# *Nomad*

## SERVICE BULLETIN

### HORIZONTAL STABILISER - REVISED CONTROL GEOMETRY (MODIFICATIONS N211 AND N211-24)

Figure 1 Horizontal Stabiliser Torque Shaft and Control Rod Linkage

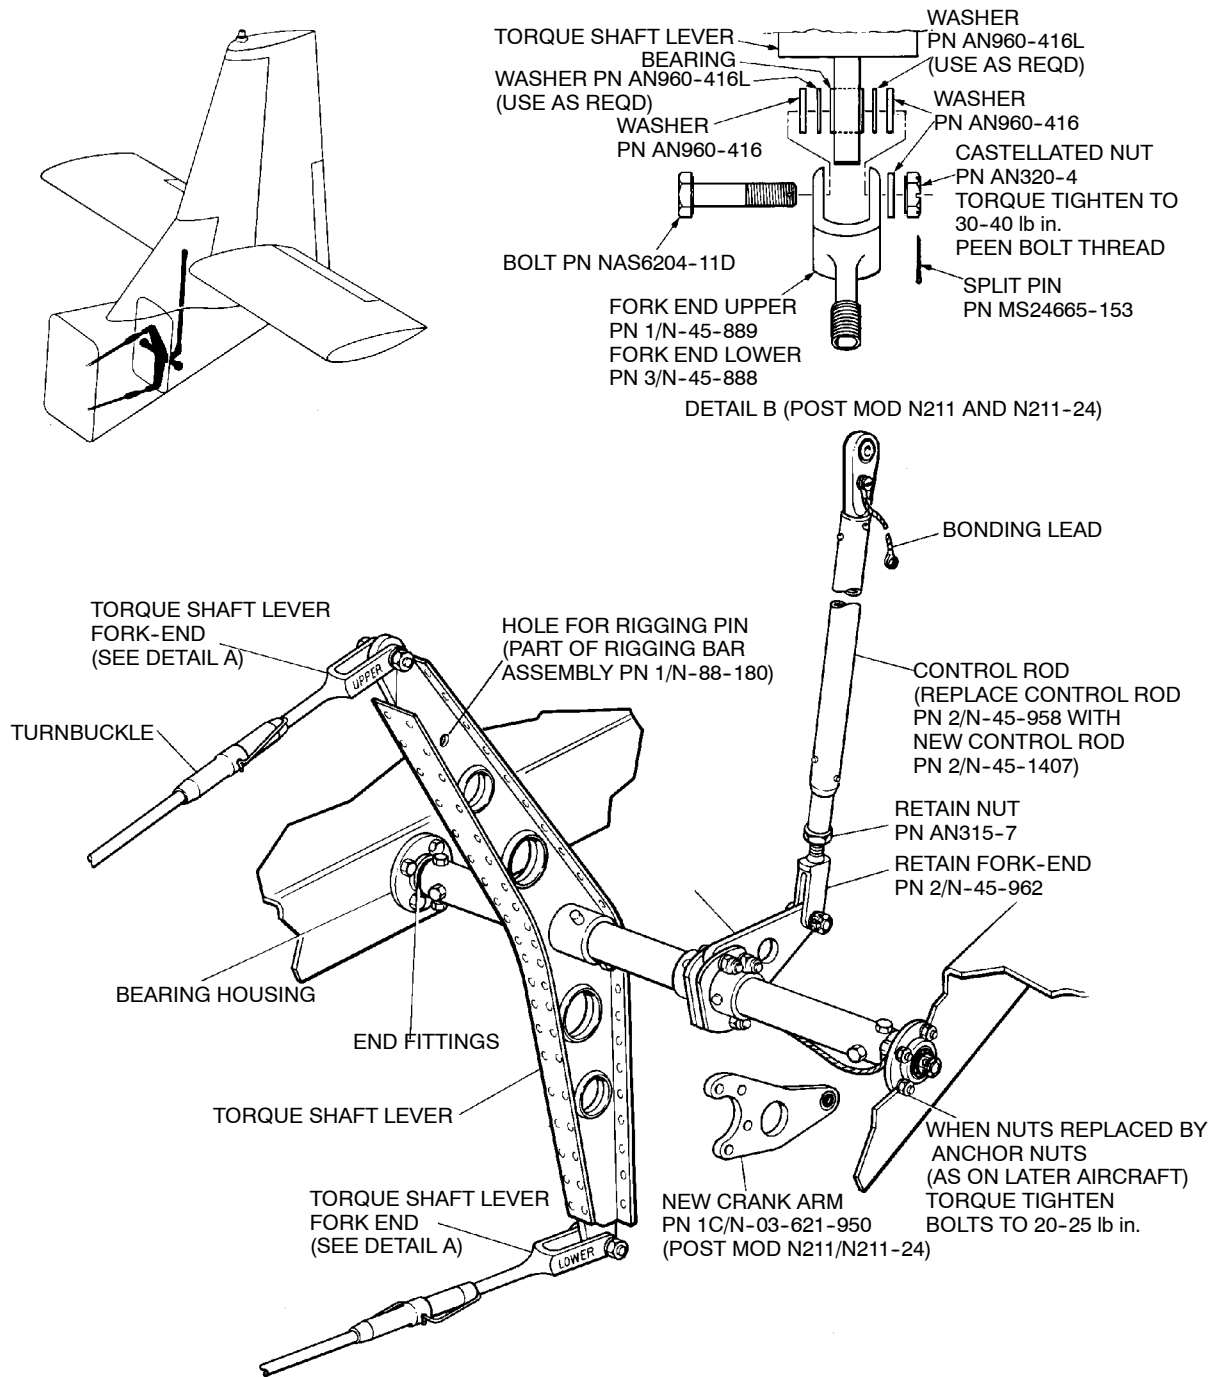
- (1) Remove the horizontal stabiliser control rod PN 2/N-45-958 (Ref MM Chap 27-40-05 and IPC Chap 27-40-02 Figure 4). Discard the split pins, but retain the other attaching parts.
- (2) Remove and retain fork-end PN 2/N-45-962 and nut PN AN315-7 from the control rod (Ref Figure 1), but discard the remainder of the control rod.
- (3) Assemble fork-end PN 2/N-45-962 and nut PN AN315-7 to new control rod PN 2/N-45-1407-950 to form new fully-assembled control rod PN 2/N-45-1407. Re-part number the new rod as PN 2/N-45-1407.

- J. Connect the UPPER fork-end PN 1/N-45-889 to the upper arm of the torque shaft lever assembly using the attaching parts and method of assembly shown in Figure 1, Detail A. Torque tighten the nut to between 30 and 40 lb inches. Fit split pin and then peen bolt thread.

**Figure 2 Preparing the New Crank Arm for Drilling and Reaming**

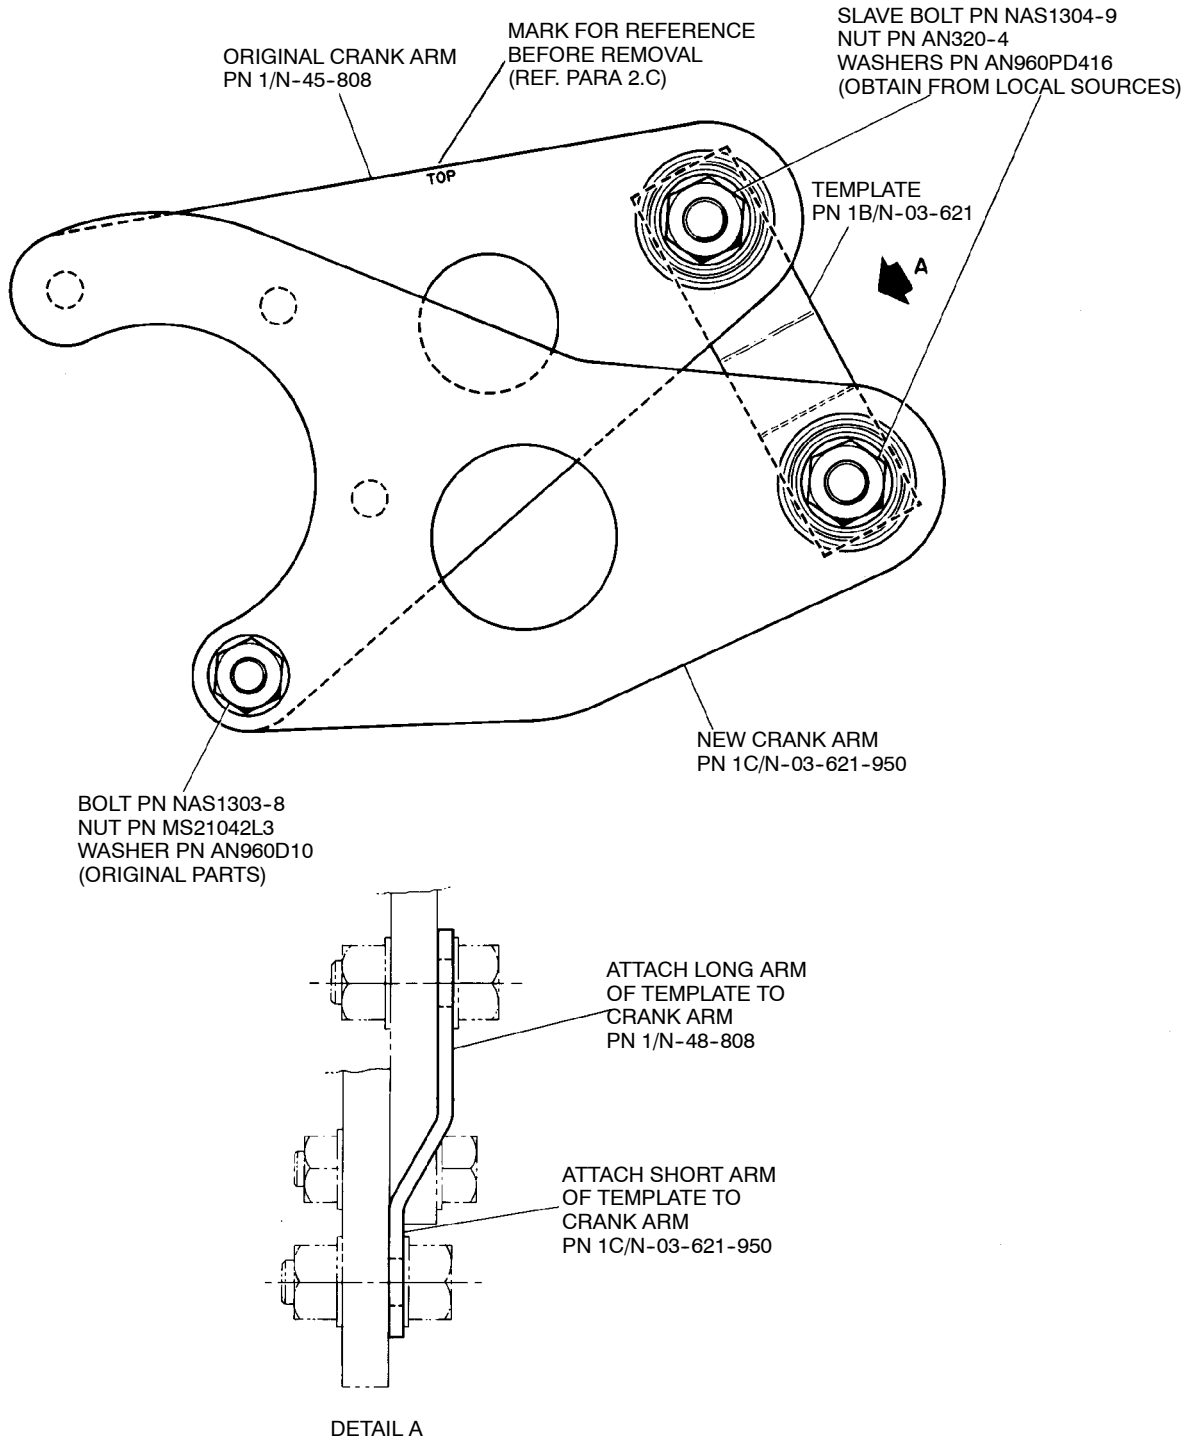
- C. Mark the top of crank arm PN 1/N-45-808 (Ref IPC. Chap 27-40-02 Figure 4) for later identification, then remove the crank arm from the torque shaft. Retain the bolts, nuts, flat washers and spring washer. Note the position where the bonding lead is fitted and the order of assembly of attaching parts.
- D. Temporarily assemble together the original crank arm PN 1/N-45-808, the new crank arm PN 1C/N-03-621-950 and template PN 1B/N-03-621 using the attaching parts and method of assembly shown in Figure 2.

**Figure 3 Installation of New Crank Arm on Torque Shaft Assembly**

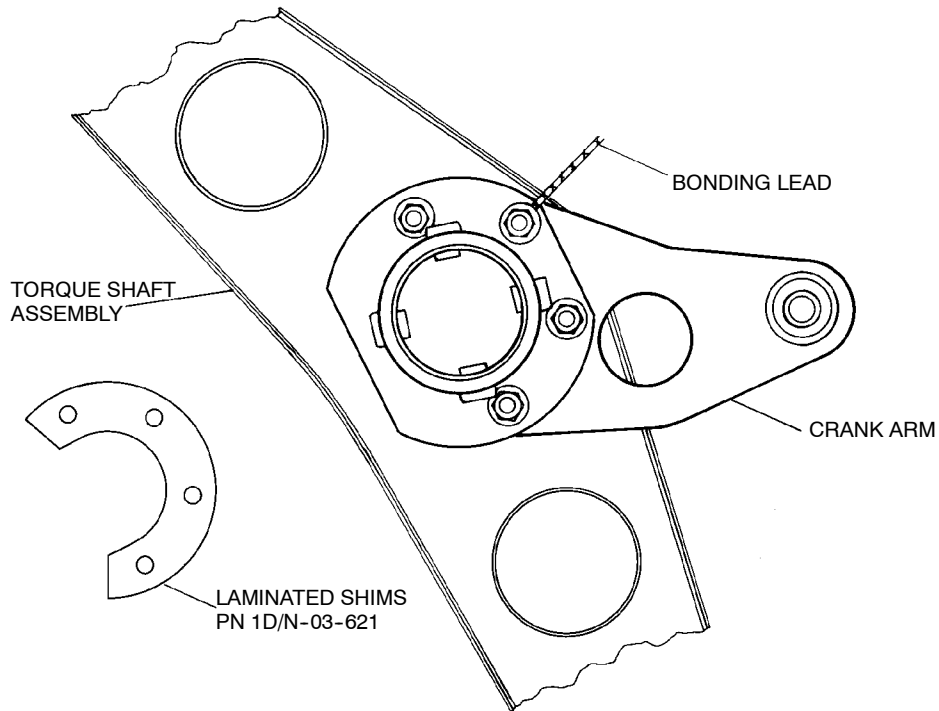
- H. Measure the gap between one of the flanges and the new crank arm (Ref Figure 4). Fit laminated shims PN 1D/N-03-621 (Ref. Figure 3) as required to ensure that the gap does not exceed 0.003 inch. Secure the crank arm to the torque shaft assembly using original nuts and washers, ensuring that the bonding lead terminal is correctly fitted (Ref Para 2.B.). Torque tighten the nuts to between 25 and 30 lb inches.

Figure 5 Locating the Rigging Hole in the Torque Shaft Lever

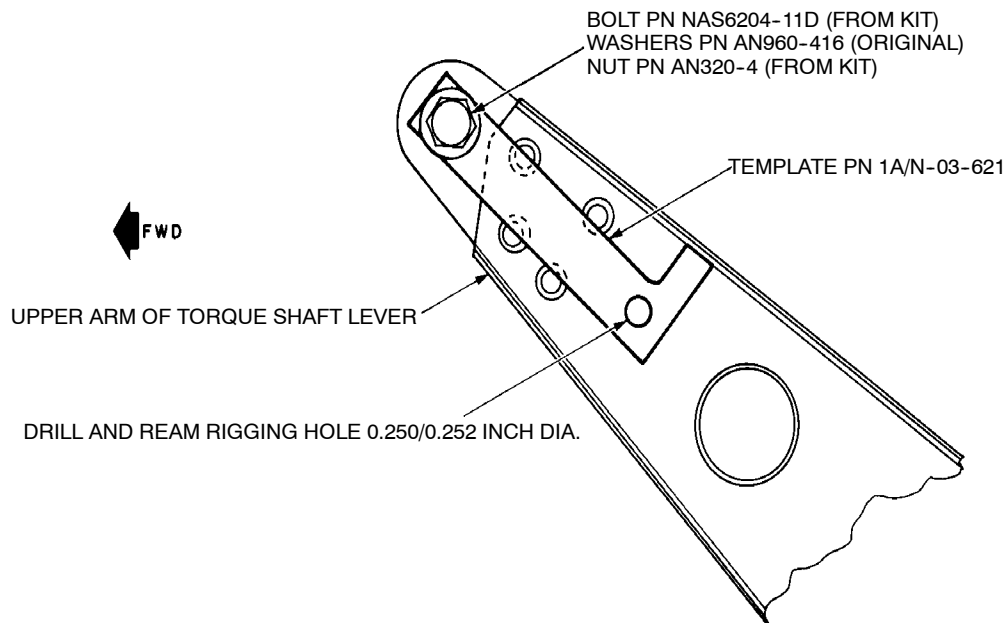
- (2) Assemble template PN 1A/N-03-621 to the upper arm of the torque shaft lever assembly (Ref Figure 5). Drill and ream the rigging hole in position illustrated. Remove the nut, washers and bolt attaching template PN 1A/N-03-621 to the torque lever assembly. Discard the template, but retain the attaching parts.

Figure 6 Template

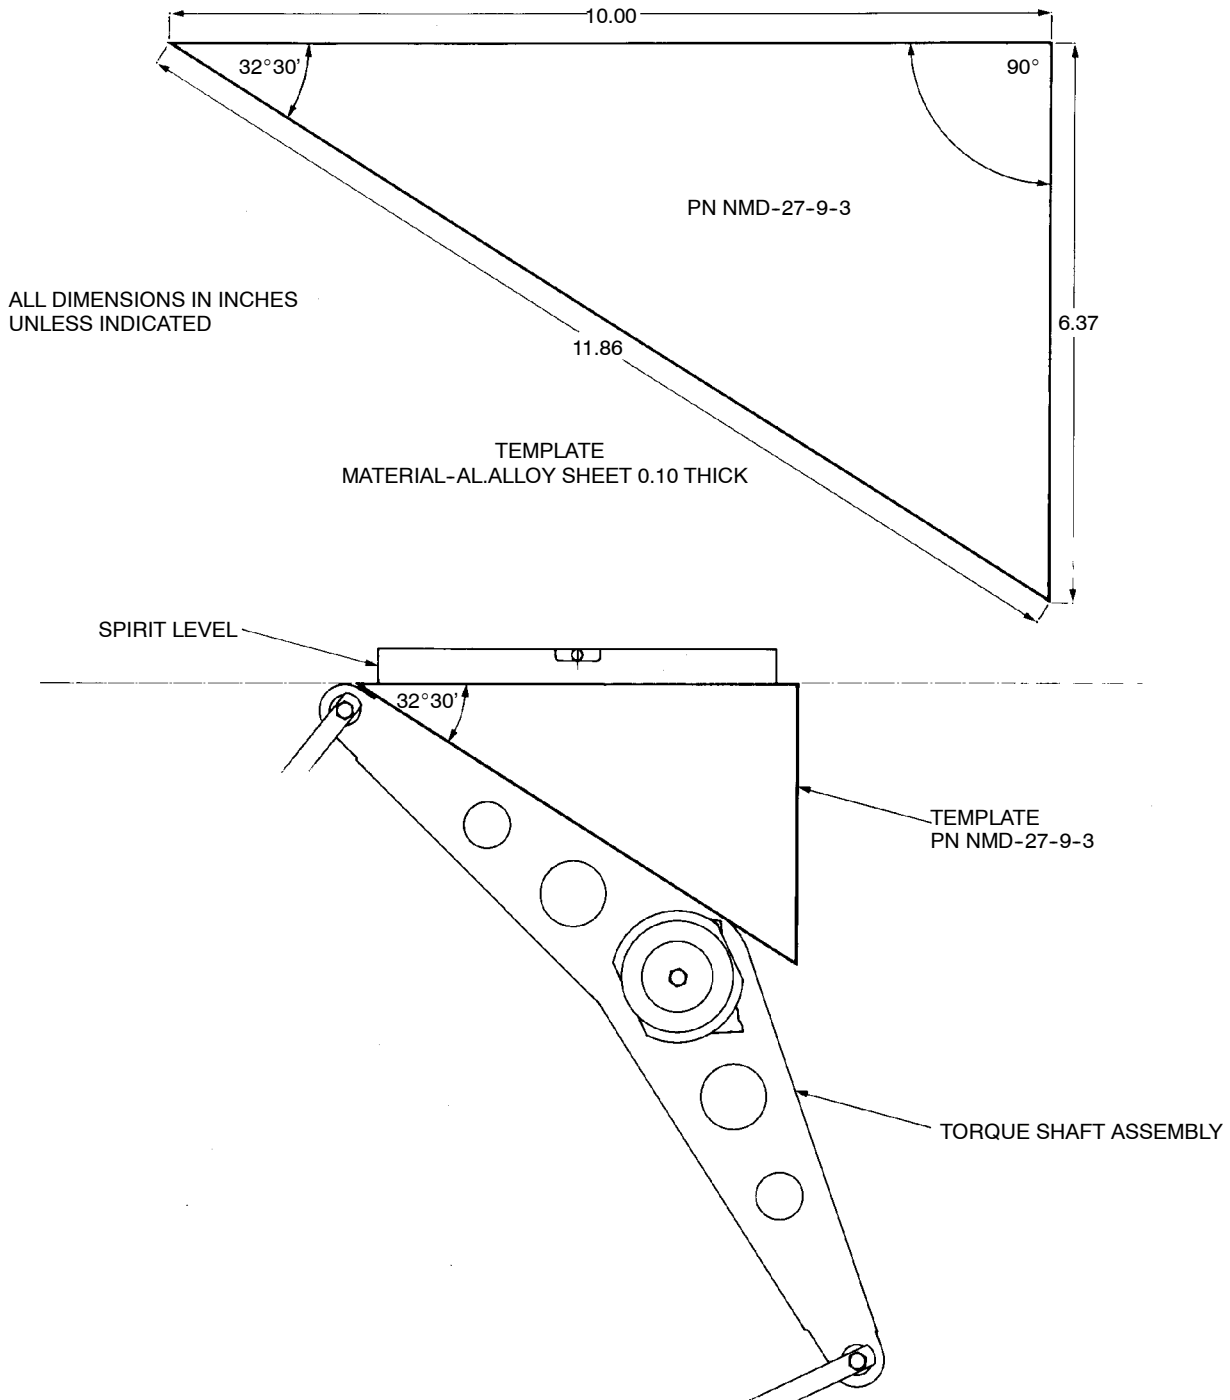
The following procedure requires the use of an inclinometer with a minimum range of 35 degrees and a scale graduated in degrees and minutes. If this type of inclinometer is not available, template NMD-27-9-3 (locally manufactured to dimensions shown in Figure 6) and a spirit level will be required.

If an inclinometer is not available, place the template and spirit level in position on the upper arm of the torque shaft lever (Ref Figure 6).
